Recall Campaign Bulletin

Campaign No. 2024070005, July 2024

SUBJECT: **Model C-Class (206 platform)**
Model Year 2022 – 2023

Check Pre-Fuse Box Wiring

Figure 1

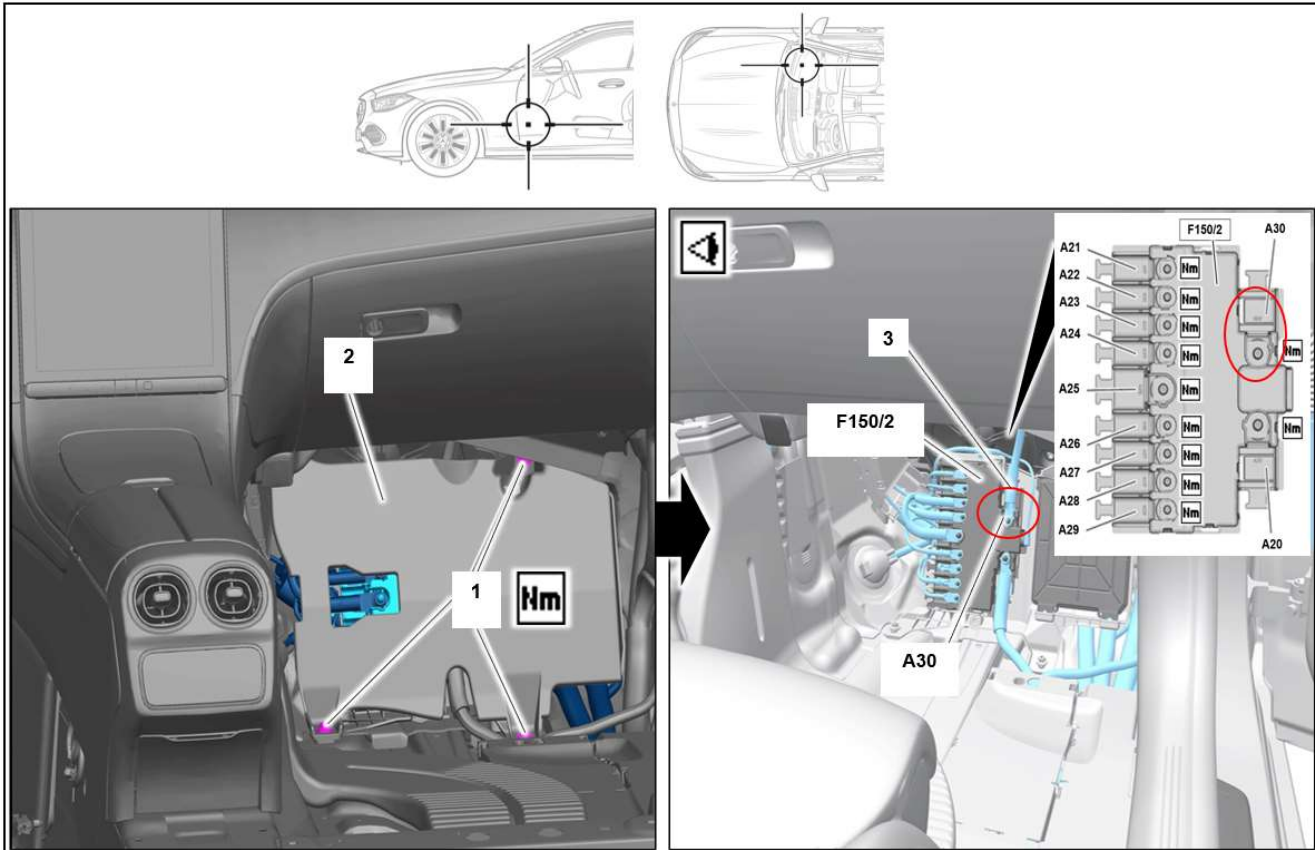
1. Remove floor covering on front passenger side.
 ⓘ For basic information, see **AR68.80-P-0008WT**.
2. Disconnect ground line of 12 V on-board electrical system battery.
 ⓘ For basic information, see **AR54.10-P-0051WT**.
3. Remove passenger side footwell support (**Figure 1, 2**).
 ⓘ For this purpose, remove nuts (**Figure 1, 1**).
 ⓘ For basic information, see **AR54.15-P-1350WT**.
 ⓘ **Installation:** Tighten nuts (**Figure 1, 1**) with the specified tightening torque of **6 Nm**.

Figure 2 (prefuse box with thermal damage, NOK)

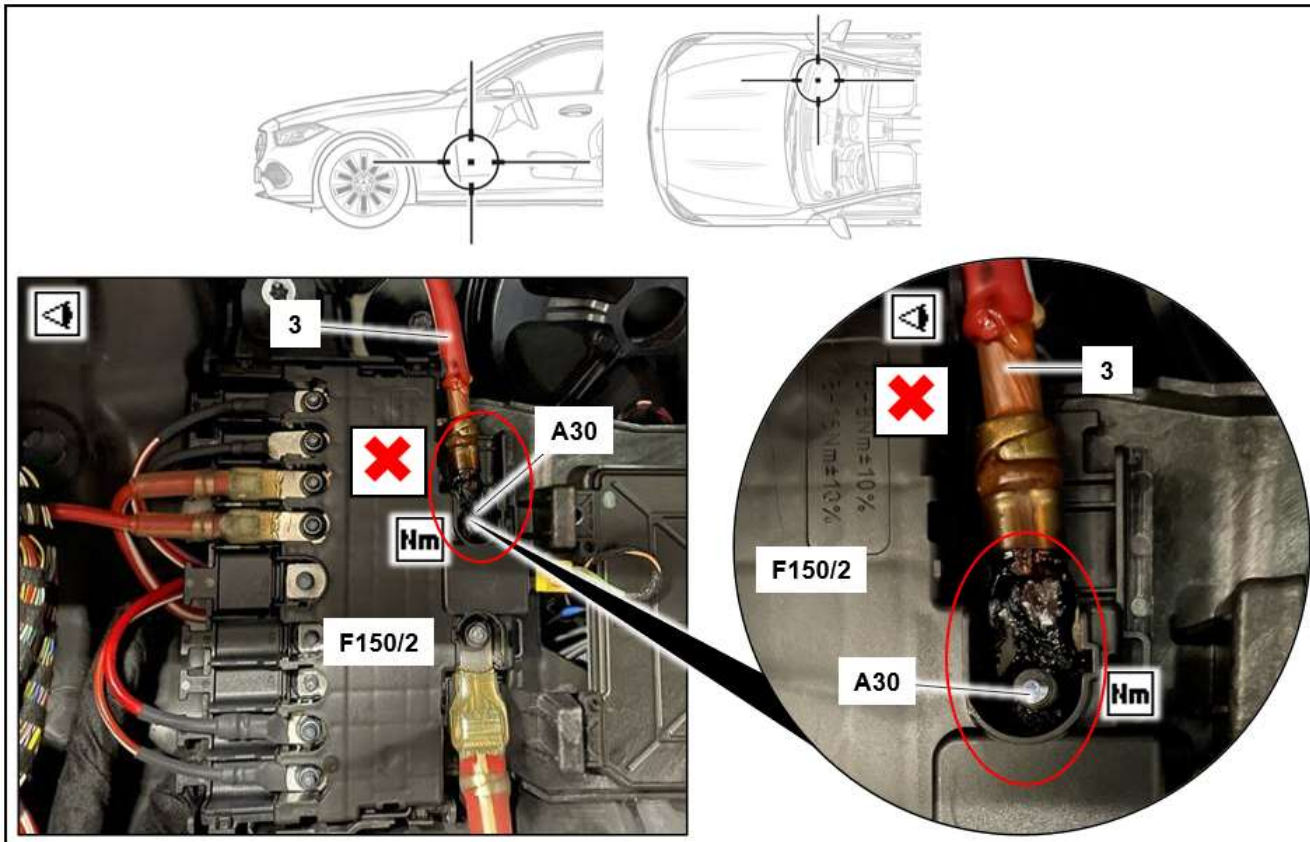
4. Inspect electrical connection (**Figure 2, A30**) of prefuse box **F150/2** visually for physical damage, such as arcing, scorch marks, melting and/or missing nut.
- If there is no damage to the electrical connection (**Figure 2, A30**), remove electric line (**Figure 2, 3**) at A30 connection and inspect the underside for damage. If there is no damage, re-install the electrical connection with nut (tightening torque of **16 Nm**) and **End Measure**.
 - If there is damage to the electrical connection (**Figure 2, A30**), carry out **Work Procedure**.
NOTE: Capture photos of damaged electrical connection to be included in Warranty claim

i Replace damaged prefuse box (Figure 2, F150/2) and/or install missing nut on electrical connection (Figure 2, A30). For basic information, see AR54.15-P-1350WT.

Figure 3 (passenger side of engine compartment)

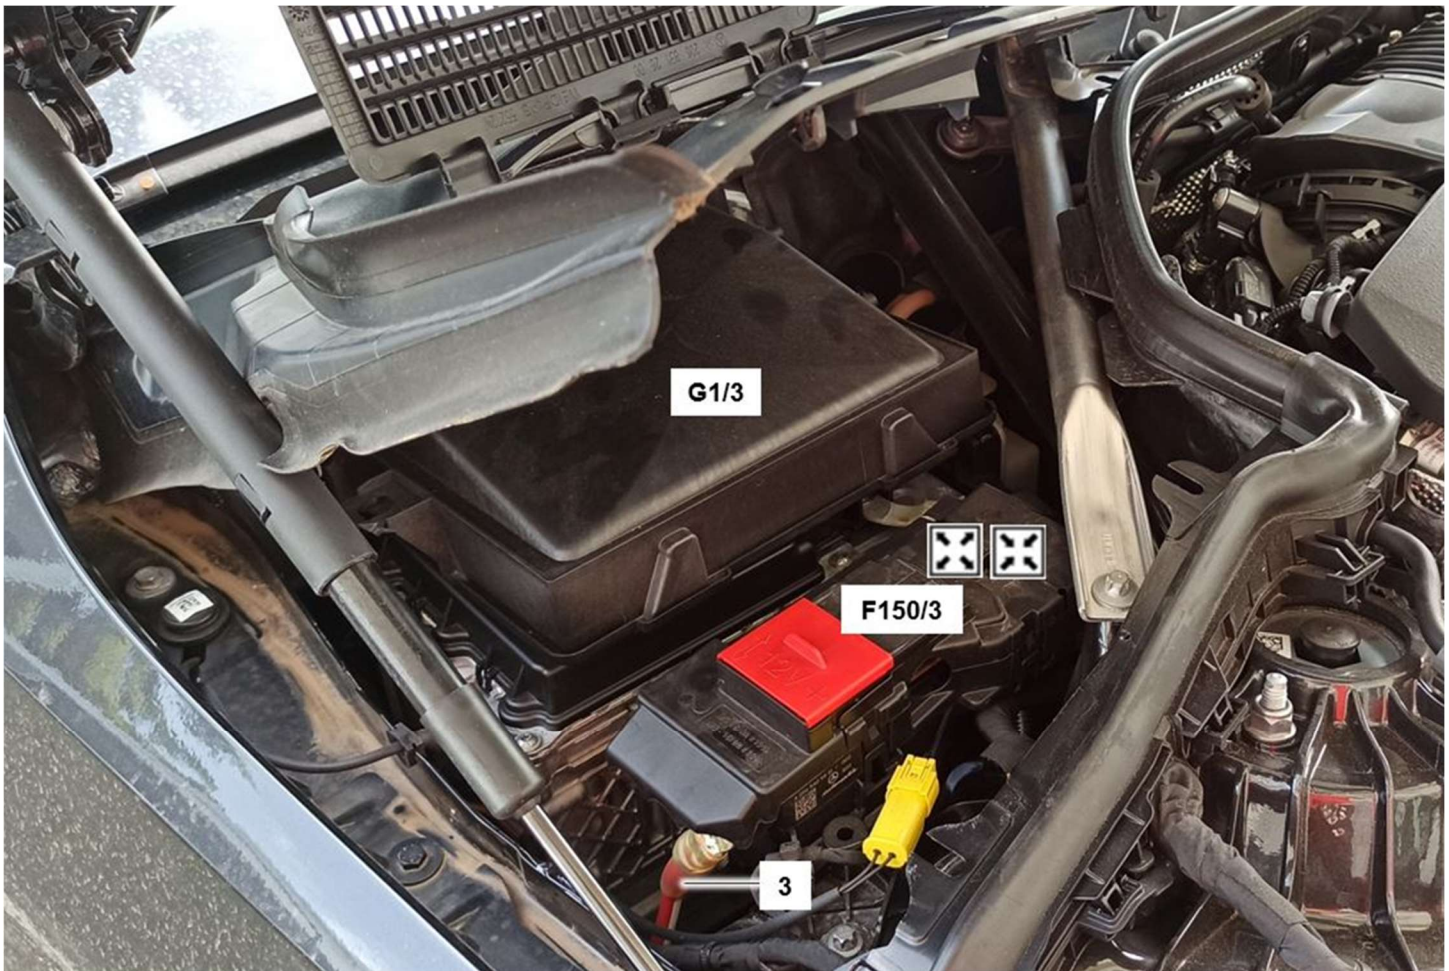
- Work Procedure Step 1 updated, Figure 3 changed, Operation Item 12-2179 description updated.

i Replace damaged electric line (Figure 3 and 4, 3):

To do this, completely remove the front prefuse box (Figure 3, F150/3) in the engine compartment (for basic information, see AR54.15-P-1330WT), and then push the 48 V battery (Figures 3 and 4, G1/3) to the side (Figure 4, direction of arrow) with only the coolant lines attached (for basic information, see AR54.10-P-0022WT).
